Re: January Planning Commission Meeting

1. Site Plan for Lots 1R and 11R, Carroll Heights Subdivision. Thomas Engineering, Agent.

Application Type: Site Plan Review

SITE PLAN REVIEW
LOTS 1 & 11, BLOCK 2
CARROLL HEIGHTS SUBDIVISION
CITY OF SHERWOOD,
PULASKI COUNTY, ARKANSAS

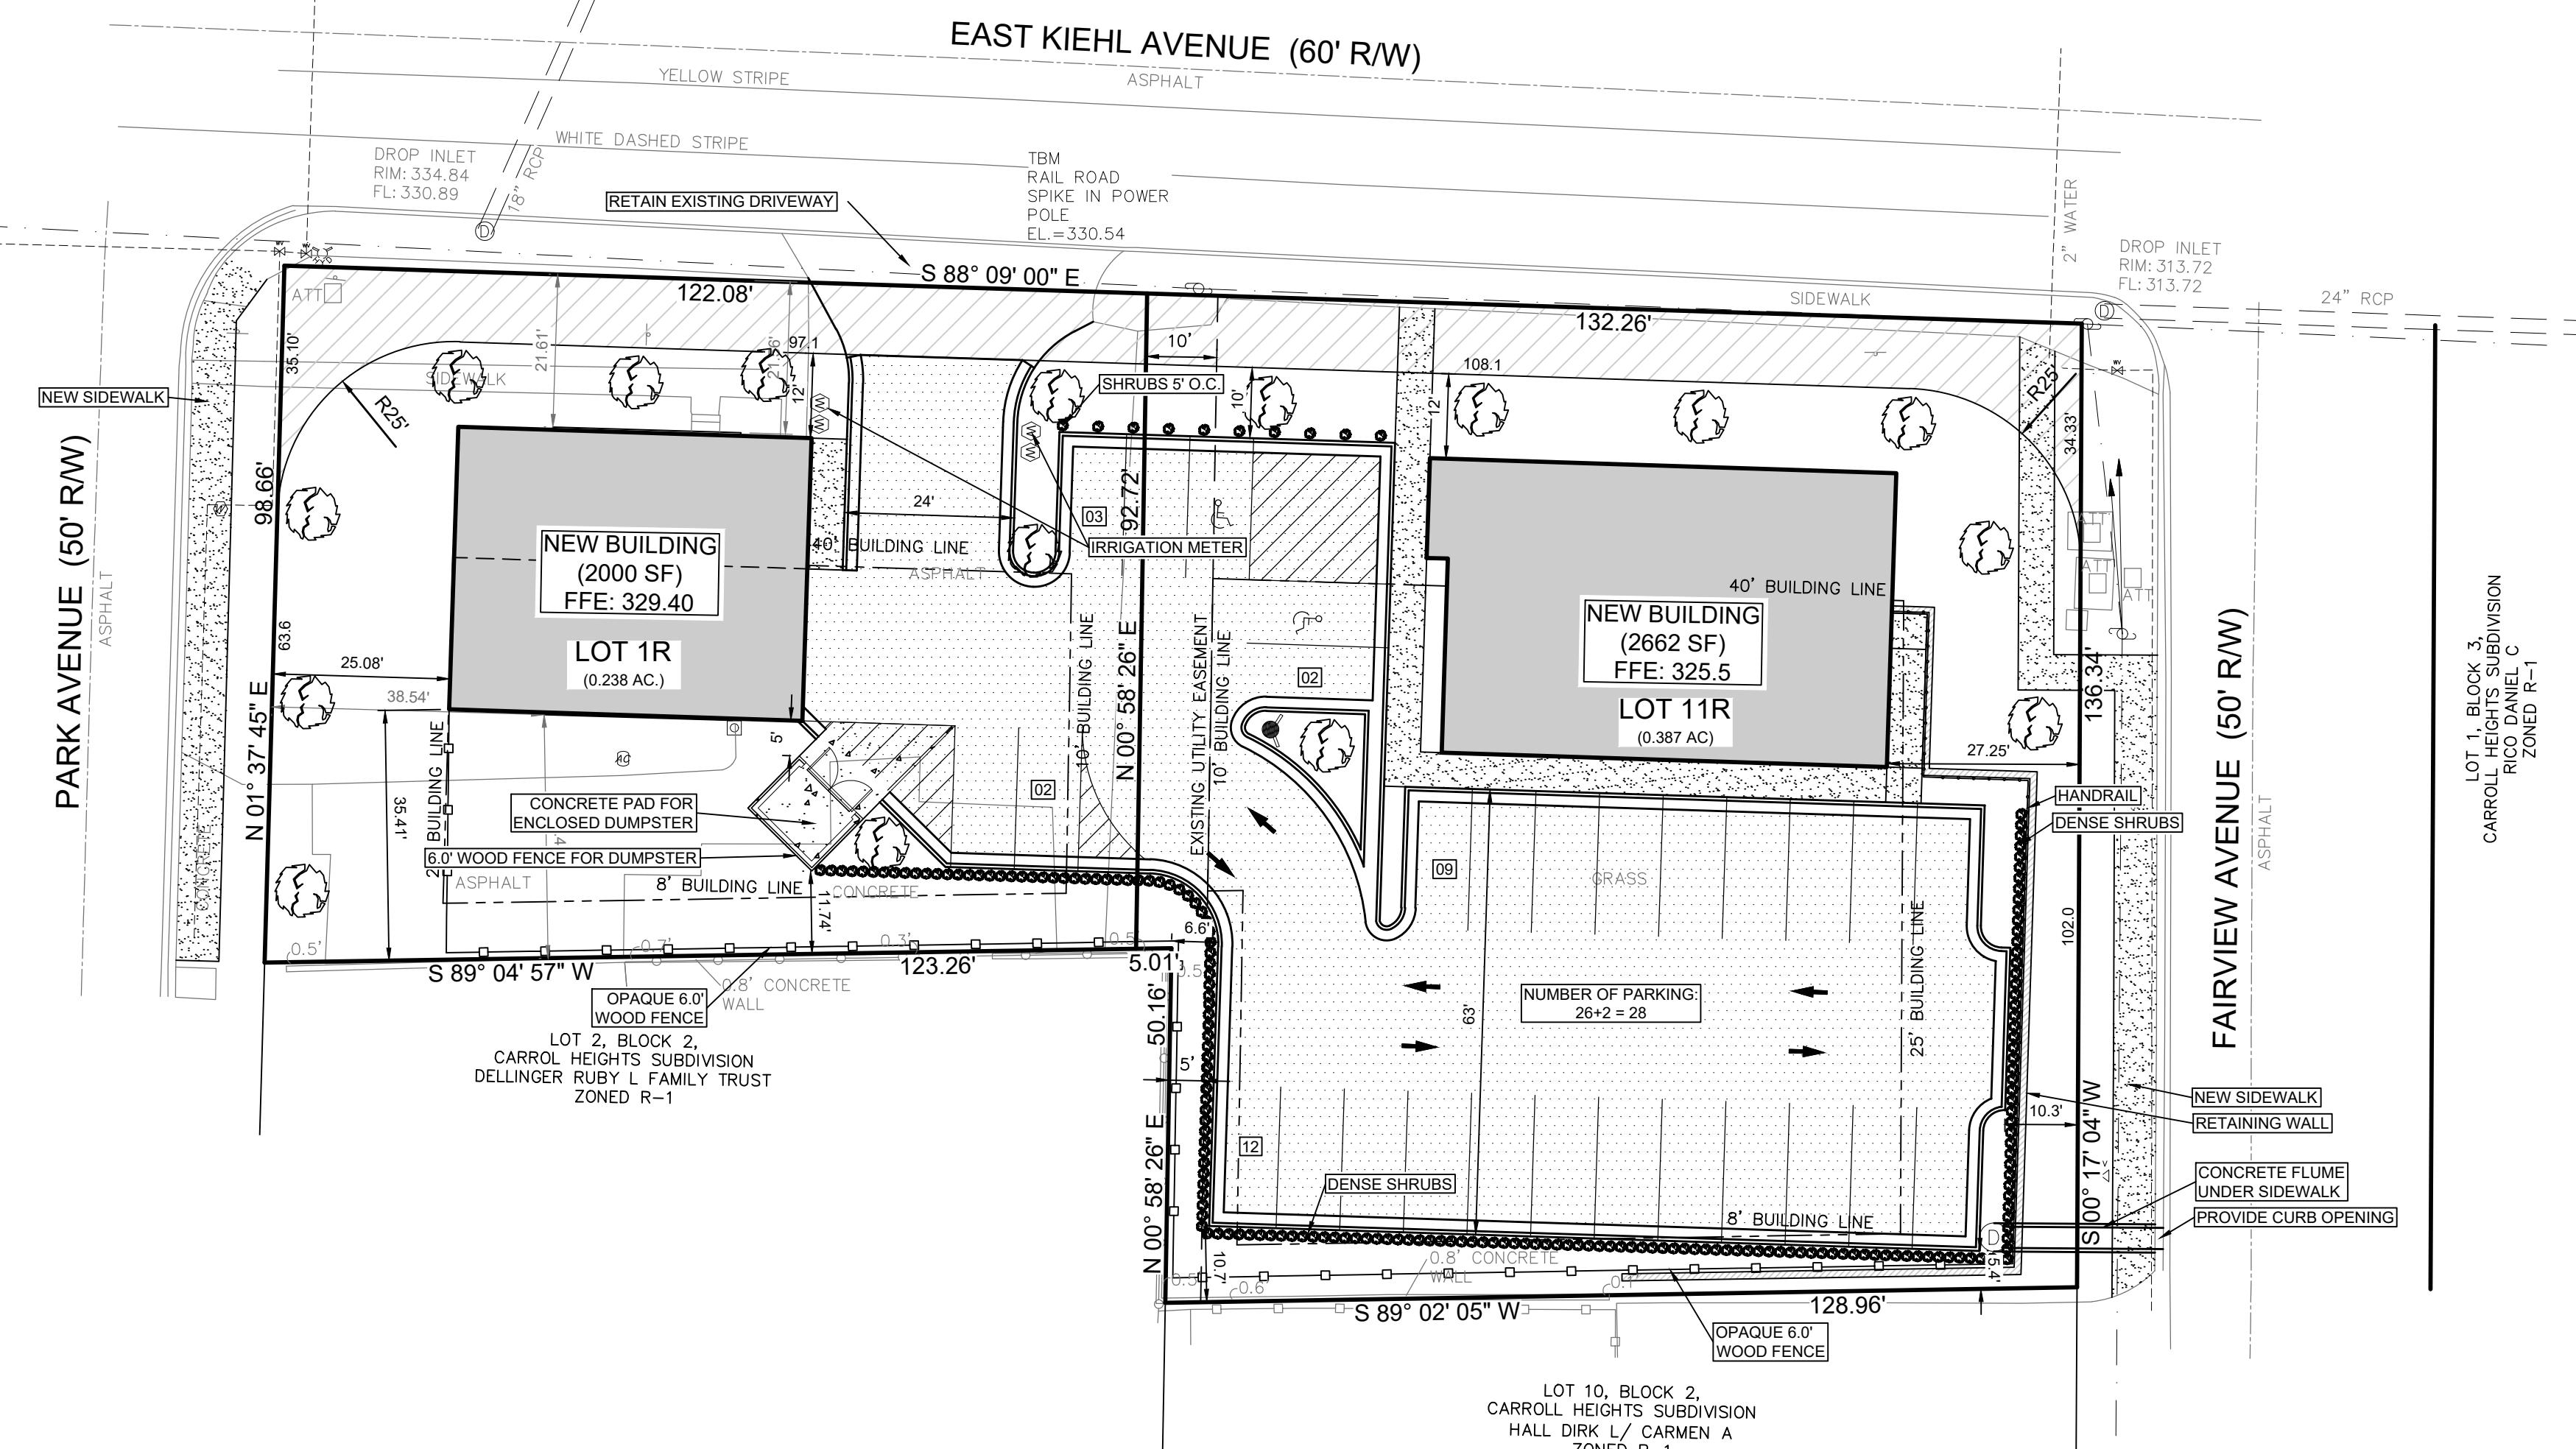
- iv. *Revise site plan to capture required sidewalk improvement on Park Ave, ensuring each individual sidewalk improvement along Park Ave and Fairview Ave meets minimum 5' sidewalk required.* #PROVIDED

1. *Will the power pole and AT&T box on Fairview Ave need to be relocated to accommodate the new sidewalk?* #NO
 - v. *Revise site plan to indicate a stub out turnaround in the main parking area to allow vehicles parking in the easternmost parking spaces to backout.* #STURB TURNOUT IS PROVIDED

- i. *Indicate building setbacks for C-2 zoning district on both lots to all property lines.*
 1. *Applicant has submitted a variance request to reduce the front yard setback across Lot 1R and Lot 11R concurrently with site plan review.*

- ii. *Fencing cannot extend past the front building line, nor beyond the side yard setback on corner lots per §14.16.08.A., however the Enforcement Officer may allow deviation to location and height requirements in accordance with §14.10.02.B.b.1.* #FENCING IS REVISED IN SW CORNER OF LOT 1R

1. *Indicate existing driveway south of Lot 1R (serving residence at 8218 Park Ave) on site plan to determine no deviation from site triangle requirements is created by the proposed 6' opaque fence terminating at the property line in accordance with §14.10.13.* #EXISTING DRIVEWAY IN LOT 1 WILL BE REMOVED, AND FENCE IS REVISED TO AVOID SUCH PROBLEM

2. *Indicate existing driveway south of Lot 11R (serving residence at 8217 Fairview Ave) on site plan to determine if obstruction is created by location of the proposed retaining wall in accordance with §14.10.13.* #WALL AND FENCING IN THE SE CORNER OF LOT 11R IS REVISED TO AVOID OBSTRUCTION.

- e. Schematic landscape plan showing proposed treatment of the areas designated as either buffers or private common open space. – *proposed landscaping plan is insufficient.*

- i. *Revise site plan to include all required perimeter, vehicular access, and buffering/screening requirements; dimension all landscape strips as required by Zoning Code §14.16* #INCLUDED

1. **6' landscape strip is required between vehicular use areas, property lines and between ROW; dimension all landscape areas indicated on site plan in accordance with §14.16.06.**

- b. **Revise site plan to indicate continuation of the 6' landscape strip required to the west along the entirety of the south property line of Lot 1R. # REVISED**

2. **Site plan indicates the required 6' landscape strip/distance from R-1 property cannot be met at the SE corner of the Lot 11R. #LANDSCAPE STRIP WIDTH VARIES FROM 10.7' to 5.4' DUE TO THE SIDE AND EXISTING GRADE OF THE LOT.**

- ii. **At minimum 5% of the interior of vehicular use area is required to be landscaped, e.g., planters/islands surrounded by concrete curb with no less than 80sf, or based on percentage calculation of vehicular use area. There must be a minimum of 1 tree in each planter/island. #PROVIDED**

1. **Note: 1 large planter containing all 5% of the required area is not permitted. #3 PLANTERS ARE SHOWN IN THE REVISED PLAN**
 2. **Note: permitter landscaping provided for screening vehicle use areas does not constitute part of the interior landscape area coverage requirements. #LANDSCAPE PLAN IS REVISED**

- iii. **Provide a legend for proposed plantings to include type, species, and quantity of each proposed plant material in accordance with requested revisions. #PROVIDED**

- iv. **Plantings proposed where C-2 property abuts R-1 shall be such to reach a minimum height of 6' within 3 years [for vehicular use areas §14.16.08.B] and shall be dense evergreen shrubbery screen to reach a minimum height of 8' and thickness of 5' within 5 years [for non-vehicular uses areas §14.16.08.E]. #ACKNOWLEDGED**

- v. **Indicate on landscape plan that all plantings shall be served by automatic irrigation, §14.16.06.D. #INDICATED**
- vi. **Dumpster location was previously discussed to be closer or attached to the proposed restaurant on Lot 1R to achieve greater separation distance from abutting residual properties. #LOCATION IS REVISED DUE TO PROVIDE EASY ACCESS FOR THE DUMP TRUCK.**

1. **Provide proposed materials for dumpster enclosure and indicate elevations on site plan, §14.16.08.C. #ADDED ON THE SITE PLAN**
- f. Location and dimension of all existing and proposed utility drainage, and street easements within the site.
Add additional easements and label easements by their intended use. #EXISTING UTILITY EASEMENT IS LABELED

- i. **Add all dimensions from building(s) to all property lines for Lot 1R and 11R. #ADDED**
 - ii. **Provide architectural elevations and listing of proposed exterior building materials in accordance with Zoning Code §14.10.10, adopted by Ordinance No. 2520 (staff to provide copy of Exterior Building Design Standards upon request), as part of the new SPL application for Lot 1R and 11R. #WILL BE PROVIDED UPON REQUEST**

- a. **Parcel size – add acreage to Lot 1R and 11R #ADDED**
- b. **Proposed floor area of principal and accessory buildings.**
- c. **Proposed number of parking spaces.
 - i. **Applicant indicates patron seating (58) + 6 employees', a minimum of 21 parking spaces is required for the restaurant proposed on Lot 11R. How was this figured? Fixed seating or sf of proposed structure? Provide interior floor/seating plan used for calculation as previously submitted. #PARKING CALCULATION PROVIDED BELOW.**
 - ii. **To confirm minimum parking requirements for Lot 1R the applicant must provide detailed description of proposed use.****

1. **Use of “Office Equipment Sales and Service” is indicated for Lot 1R with a minimum parking requirement of 5 spaces.** #PARKING CALCULATION PROVIDED.
- iii. **Provide a general note indicating all parking space dimensions are consistent with the 1 dimensioned space indicating typical parking space dimension of 20’x9’.** #ADDED AS NOTE 13.

- a. **Provide runoff calculations/pre- and post-drainage report.** #WILL BE PROVIDED UPON COMPLETION OF DESIGN
- b. **What is the plan to capture runoff leaving the parking area at the SE corner of Lot 11R near the proposed retaining wall?** #RUNOFF WILL BE DRAIN INTO FAIRVIEW AVE, THIS IS WHERE THE EXISTING RUNOFF DRAINS.
- c. **How will the site be graded where impact or cross over to adjoining property does not occur?** #SITE WILL BE GRADED TO DRAIN RUNOFF TOWARDS SE CORNER OF LOT 11R, THEN INTO FAIRVIEW AVE.
- d. **Provide engineering plans for the proposed retaining walls.**

- a. **Indicate site lighting on plan including location and fixture type.** #WILL BE PROVIDED UPON FINAL DESIGN
- b. **Is the intended commercial subdivision subjected to phased development?** #NO

- c. **Correct street name of East Kiehl Road to East Kiehl Avenue. Ensure ROW is dimensioned from C/L of roadway to reflect that of recent ROW dedication.** #CORRECTED

- d. **Has the Replat approved November 10, 2025 been filed with the County recorder?** #NO, REPLAT WILL BE FILED UPON FINAL DESIGN
- e. **Applicant must provide a detailed description of the use proposed for Lot 1R [SubZero HVAC] to ensure said use is permitted and to confirm minimum parking requirements.** #OFFICE FOR HVAC SERVICING, PARKING TYPE 6, 3000 SF WILL REQUIRE 5 SPACES

- iii. *An approved fire apparatus turnaround or secondary point of ingress/egress is not provided. Adequate turnaround must be provided in accordance with AFPC Appendix D Section 103.4. Not addressed; applicant must indicate fire apparatus turnaround on the site plan [see #5.g.].*

- iv. *Revise site plan to capture required sidewalk improvement on Park Ave, ensuring each individual sidewalk improvement along Park Ave and Fairview Ave meets minimum 5' sidewalk required.*

- v. *Revise site plan to indicate a stub out turnaround in the main parking area to allow vehicles parking in the easternmost parking spaces to backout. Captured on site plan; applicant must dimension stub out turnaround.*

- i. *Indicate building setbacks for C-2 zoning district on both lots to all property lines. Addressed*
 1. *Applicant has submitted a variance request to reduce the front yard setback across Lot 1R and Lot 11R concurrently with site plan review. Site plan as submitted indicates the reduced front yard setback on Lot 1R and Lot 11R, as requested.*

1. *Indicate existing driveway south of Lot 1R (serving residence at 8218 Park Ave) on site plan to determine no deviation from site triangle requirements is created by the proposed 6' opaque fence*

terminating at the property line in accordance with §14.10.13. Applicant revised site plan to indicate termination of 6' opaque fencing at the 25' building line adjacent to Park Ave [See 1.e.i.1.b].

2. *Indicate existing driveway south of Lot 11R (serving residence at 8217 Fairview Ave) on site plan to determine if obstruction is created by location of the proposed retaining wall in accordance with §14.10.13. Addressed; site plan revised to avoid possible obstructed view of the adjacent residential use existing to Fairview Ave.*

e. Schematic landscape plan showing proposed treatment of the areas designated as either buffers or private common open space. – ***proposed landscaping plan [captured on site plan] is insufficient; applicant must provide a separate landscape plan.***

- i. *Revise site plan to include all required perimeter, vehicular access, and buffering/screening requirements; dimension all landscape strips as required by Zoning Code §14.16.*

1. *6' landscape strip is required between vehicular use areas, property lines and between ROW; dimension all landscape areas indicated on site plan in accordance with §14.16.06. Action required*

- i. *A minimum of 1 tree every 30 linear feet and 1 shrub every 5 linear feet is required, in addition to appropriate ground covers, grasses, etc.*
 - b. *Revise site plan to indicate continuation of the 6' landscape strip required to the west along the entirety of the south property line of Lot 1R. Not addressed; revise plan to show continuation of a 6' landscape strip the entirety of the south property line to the west property line boundary on Lot 1R. Dense evergreen shrubbery must be provided.*

2. *Site plan indicates the required 6' landscape strip/distance from R-1 property cannot be met at the SE corner of the Lot 11R. Not addressed; applicant indicates the full 10'-7" to 5'-4" are on Lot 11R is landscape strip, however the area is inclusive of the proposed fence and retaining wall.*

- ii. *At minimum 5% of the interior of vehicular use area is required to be landscaped, e.g., planters/islands surrounded by concrete curb with no less than 80sf or based on percentage calculation of vehicular use area. There must be a minimum of 1 tree in each planter/island. See below.*

1. *Note: 1 large planter containing all 5% of the required area is not permitted. Revisions required.*
 2. *Note: permitter landscaping provided for screening vehicle use areas does not constitute part of the interior landscape area coverage requirements. Revisions required; perimeter landscape treatments cannot be used to satisfy vehicular use area landscaping requirements.*

- iii. *Provide a legend for proposed plantings to include type, species, and quantity of each proposed plant material in accordance with requested revisions. Partially addressed; applicant must indicate the quantity of each proposed plant material in the provided legend.*

- v. *Indicate on landscape plan that all plantings shall be served by automatic irrigation, §14.16.06.D. Irrigation not addressed; separate, revised landscape plan not provided.*

1. *Provide proposed materials for dumpster enclosure and indicate elevations on site plan, §14.16.08.C.*
Not addressed; applicant indicates enclosure materials and elevations are provided but do not appear to be captured in revisions submitted 12/29/2025.

- i. *Add all dimensions from building(s) to all property lines for Lot 1R and 11R. Partially addressed; applicant must indicate setback from both proposed new constructions on Lot 1R and Lot 11R to all property lines.*

- c. Proposed number of parking spaces.
 - i. *Applicant indicates patron seating (58) + 6 employees', a minimum of 21 parking spaces is required for the restaurant proposed on Lot 11R. Not addressed; How was this figured? Fixed seating or sf of proposed structure? Provide interior floor/seating plan used for calculation as previously submitted.*

- ii. *Provide a general note indicating all parking space dimensions are consistent with the 1 dimensioned space indicating typical parking space dimension of 20'x9'. Addressed; applicant provided General Note #13 to satisfy staff comment.*

- a. *Indicate site lighting on plan including location and fixture type. Not addressed; applicant must indicate on site plan the type and location of lighting fixture(s) proposed on site for staff review.*

- c. *Correct street name of East Kiehl Road to East Kiehl Avenue. Ensure ROW is dimensioned from C/L of roadway to reflect that of recent ROW dedication. Addressed; ROW as presented on the site plan is accurate pending recordation of the Replat approved November 10, 2025.*
